**ATTACHMENT 2**

**NMED COMMENTS ITEM 2 –**

**REPOSITORY RECONFIGURATION OF PANELS 9 AND 10**

**Figure D-5**  
**Underground Emergency Equipment Locations and Underground Evacuation Routes**

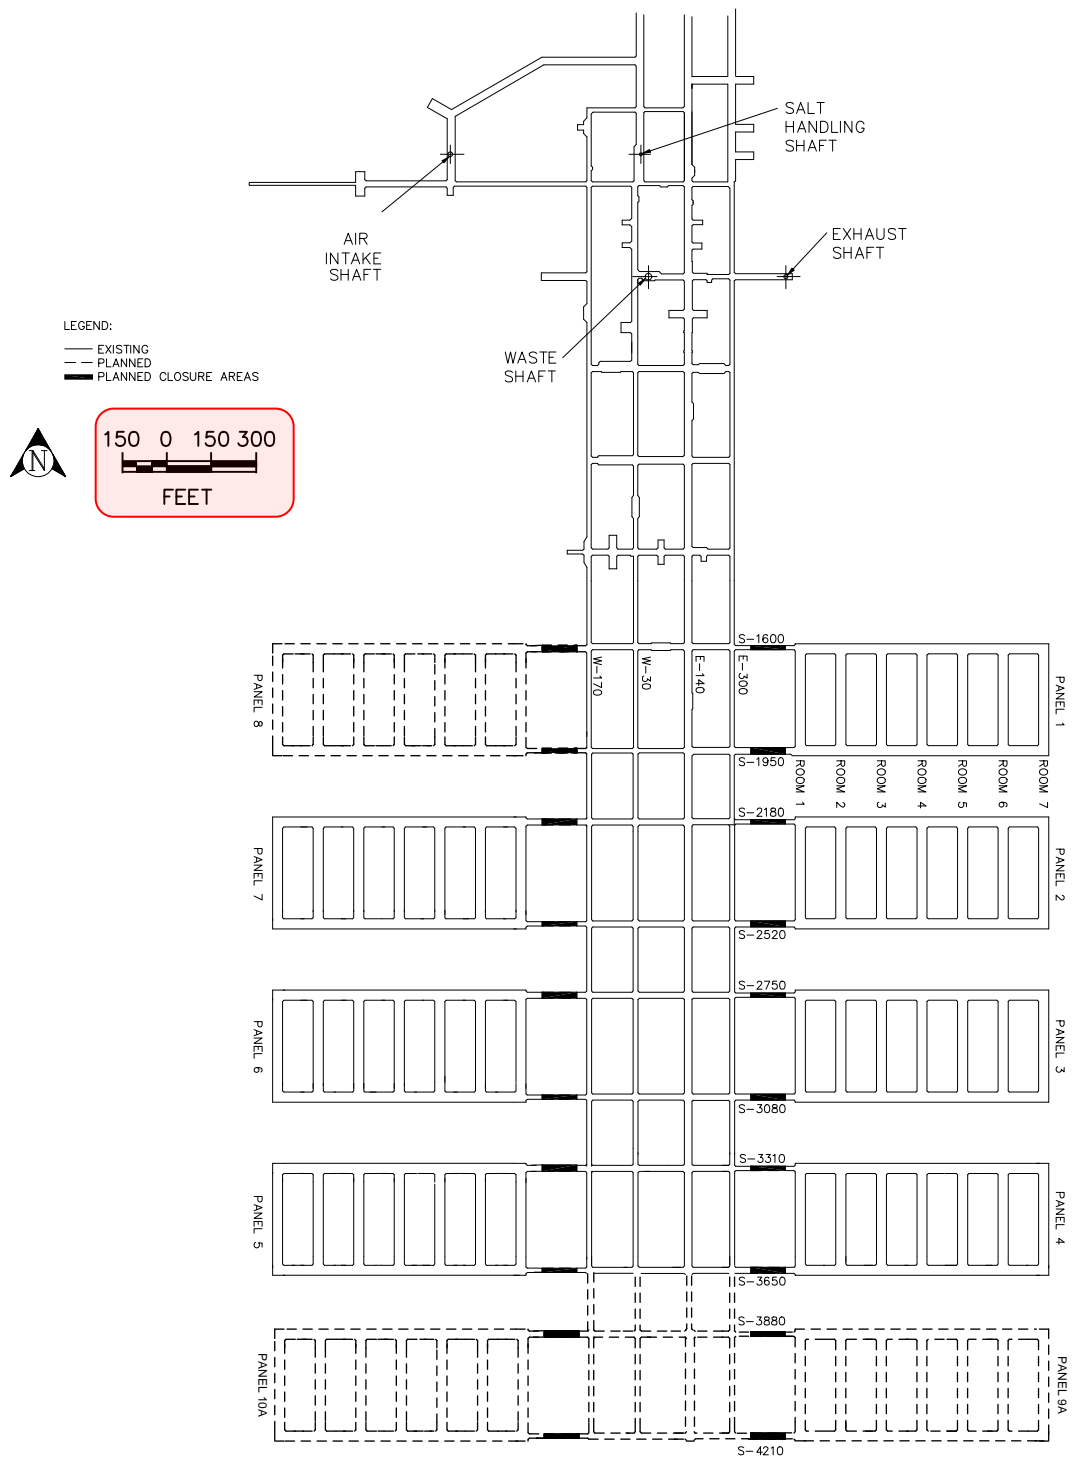
## **2-8: Figure D-5, Underground Emergency Equipment Locations and Underground Evacuation Routes, Pages C-8 and C-23**

Revise figure to include planned and existing panels to the legend, and add Panels 9A and 10A as planned panels.

### **Response:**

The Permittees have revised this figure as suggested. In addition, the Permittees have made editorial corrections to update the figure to current WIPP facility conditions. A revised figure is provided in Appendix 2-B. The portions of the figure that were changed are marked with red shading.

**Figure G-6**  
**Approximate Location of Boreholes in Relation to the WIPP Underground**

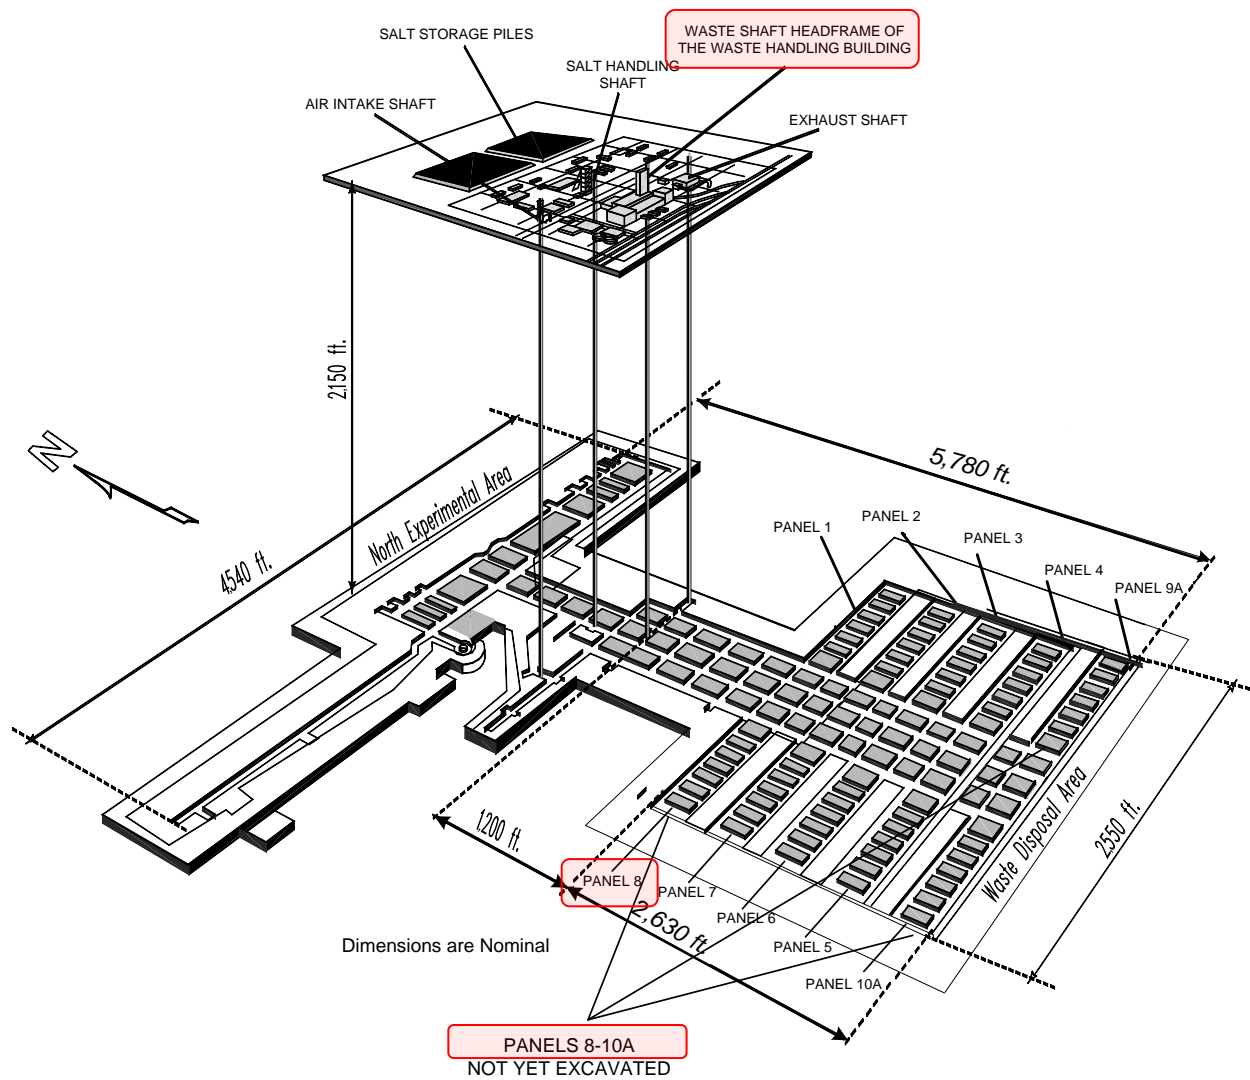
**2-9: Figure G-6, Approximate Location of Boreholes in Relation to the WIPP Underground, Pages C-11 and C-26**

Revise figure to include location markers for WIPP-19 and H-16.

**Response:**

The Permittees have revised this figure as suggested. In addition, the Permittees have made editorial corrections to update the figure to current WIPP facility conditions. A revised figure is provided in Appendix 2-B. The portions of the figure that were changed are marked with red shading.

**Figure G2-1**  
**View of the WIPP Underground Facility**

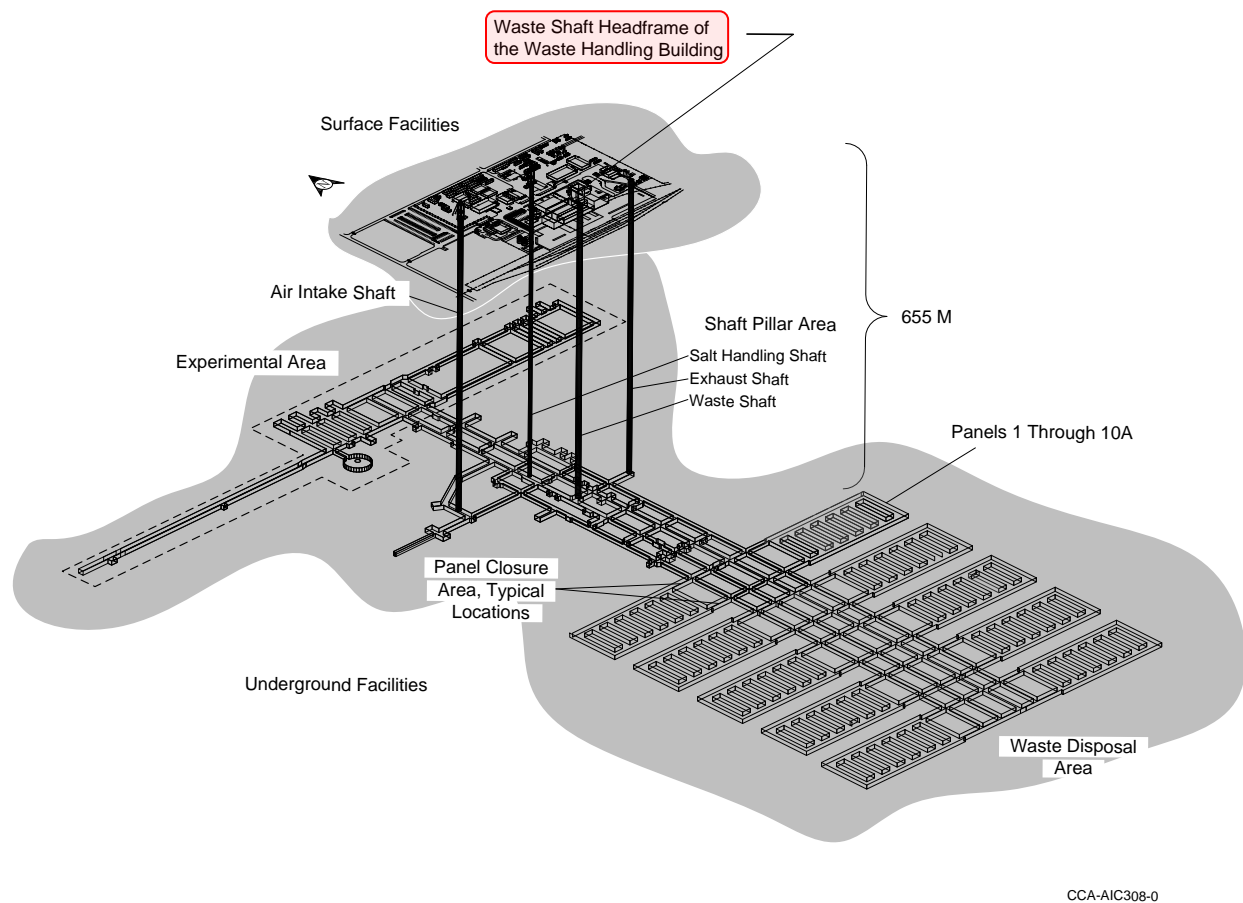
**2-10: Figure G2-1, View of the WIPP Underground Facility, Pages C-12 and C-27**

Revise figure label to read “PANELS 8-10A NOT YET EXCAVATED”

**Response:**

The Permittees have revised this figure as suggested. In addition, the Permittees have made editorial corrections to update the figure to current WIPP facility conditions. A revised figure is provided in Appendix 2-B. The portions of the figure that were changed are marked with red shading.

**Figure H1-1**  
**Spatial View of WIPP Surface and Underground Facilities**

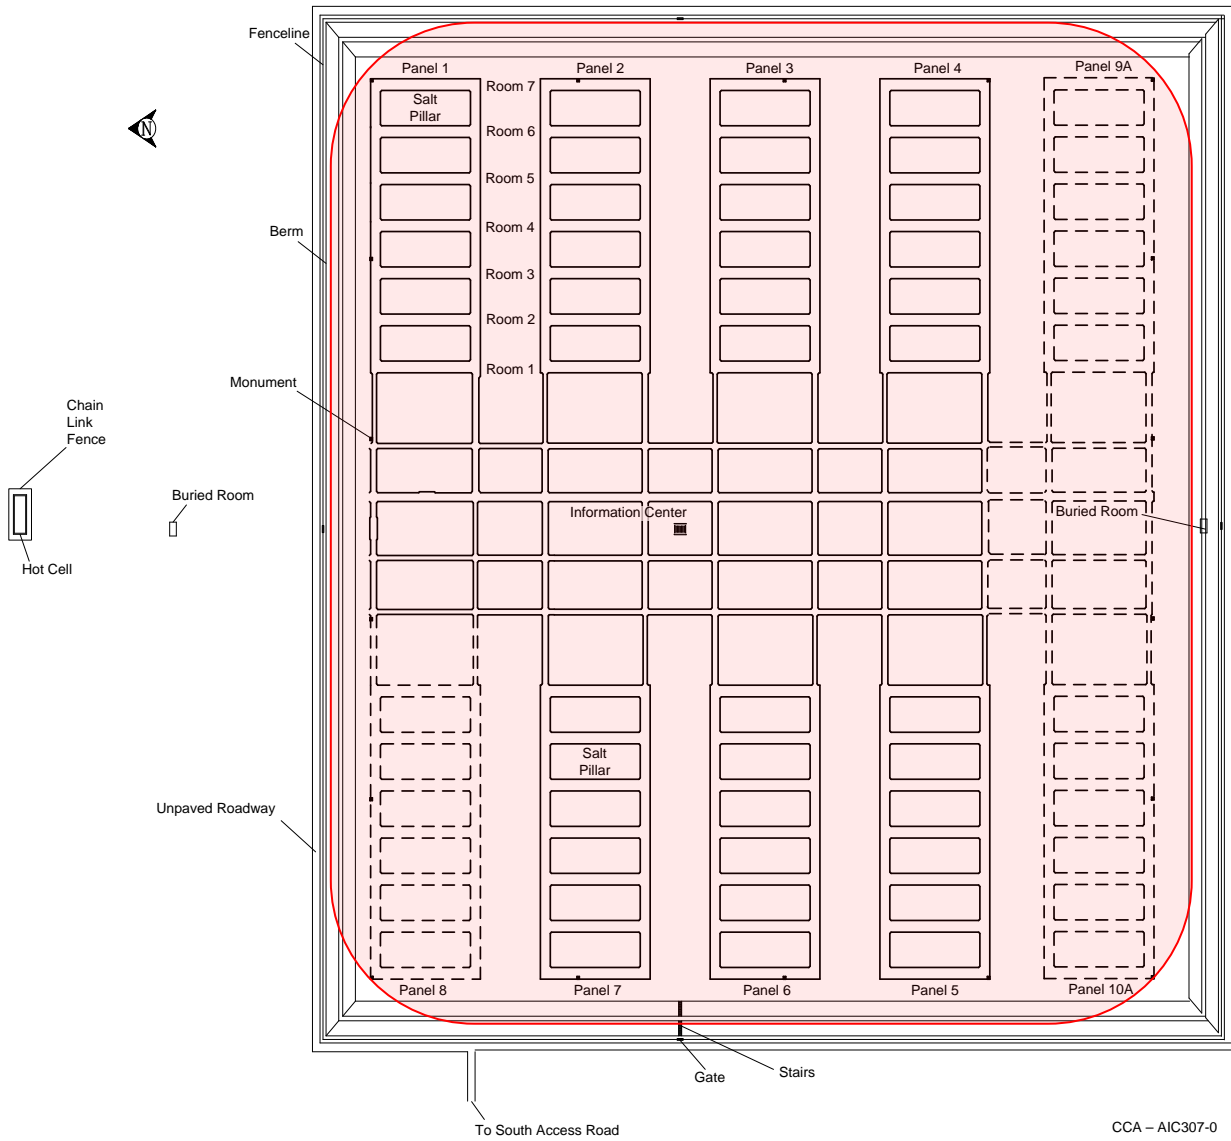
## **2-11: Figure H1-1, Spatial View of WIPP Surface and Underground Facilities, Pages C-13 and C-28**

The figure in the PMR is not the correct figure that is referenced in the Permit. The correct figure must be initially referenced in the PMR. Any proposed changes to the figure can then be requested.

### **Response:**

The Permittees have revised this figure as suggested. In addition, the Permittees have made editorial corrections to update the figure to current WIPP facility conditions. A revised figure is provided in Appendix 2-B. The portions of the figure that were changed are marked with red shading.

**Figure H1-4**  
**Perimeter Fenceline and Roadway**

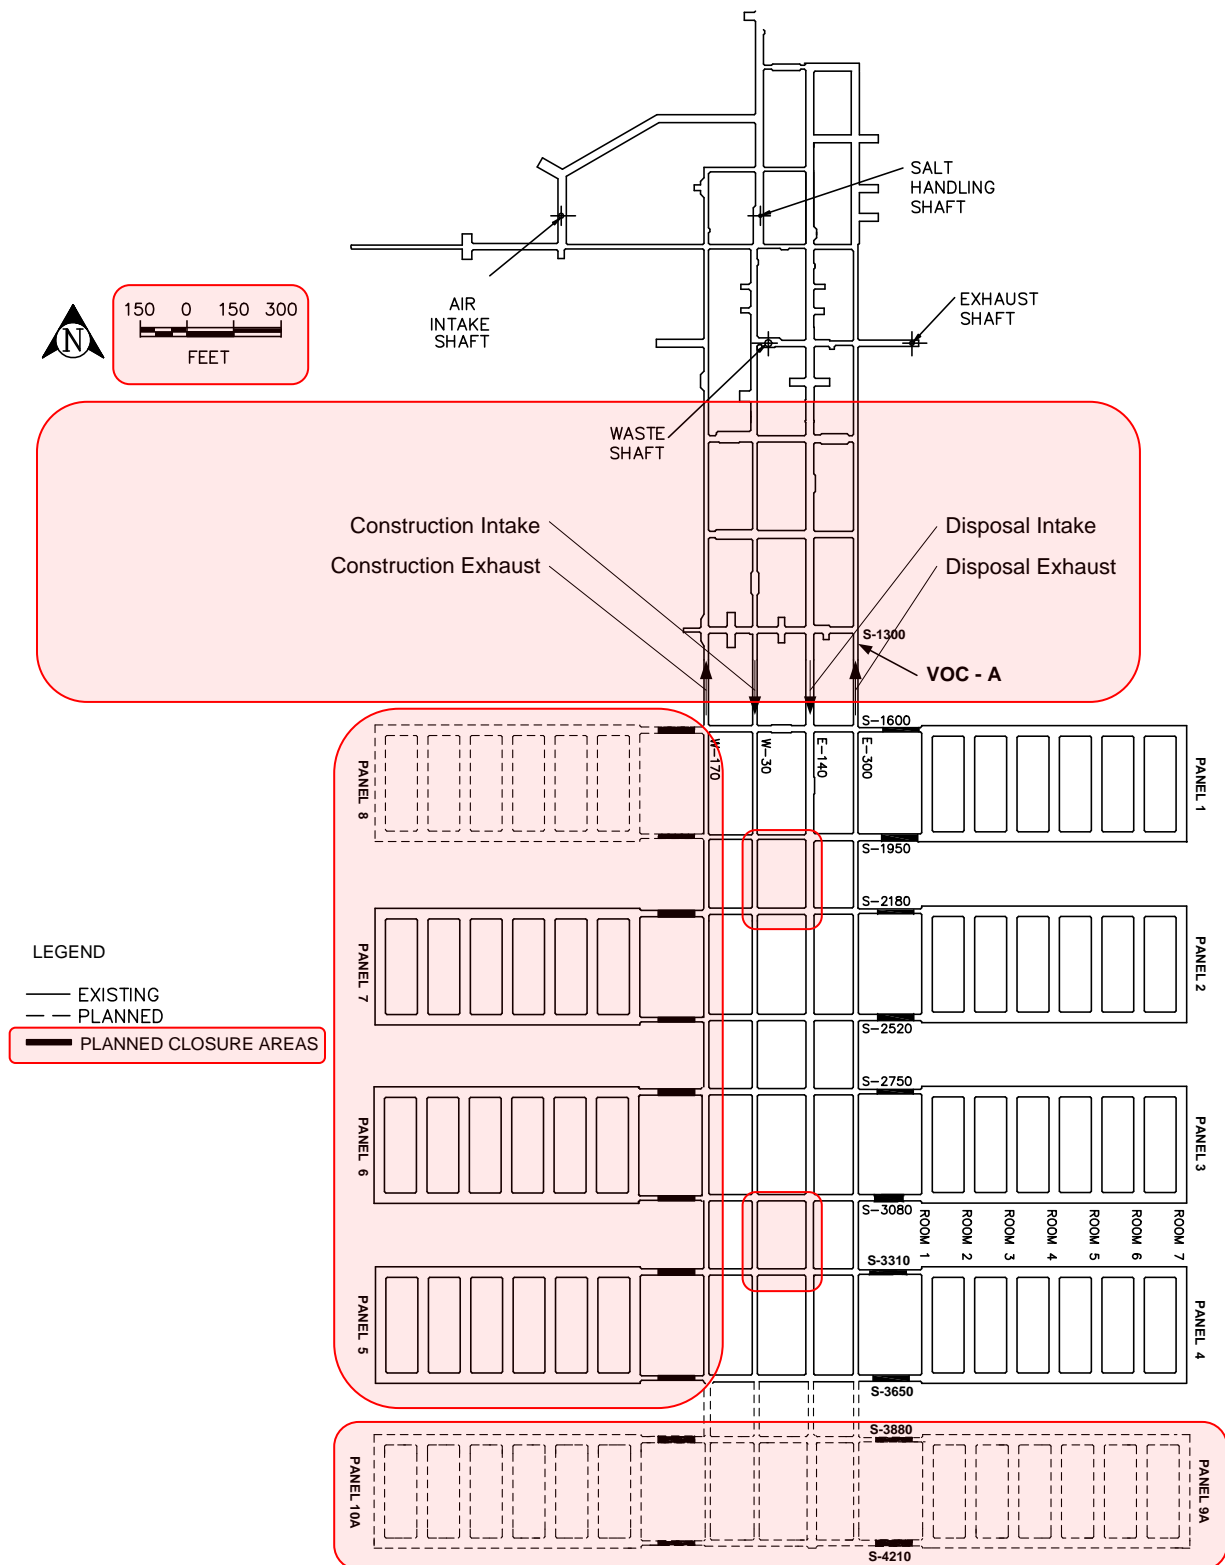
## **2-12: Figure H1-4, Perimeter Fenceline and Roadway, Pages C-14 and C-29**

The figure in the PMR is not the correct figure that is referenced in the Permit. The correct figure must be initially referenced in the PMR. Any proposed changes to the figure can then be requested.

### **Response:**

The Permittees have revised this figure as suggested. In addition, the Permittees have made editorial corrections to update the figure to current WIPP facility conditions. A revised figure is provided in Appendix 2-B. The portions of the figure that were changed are marked with red shading.
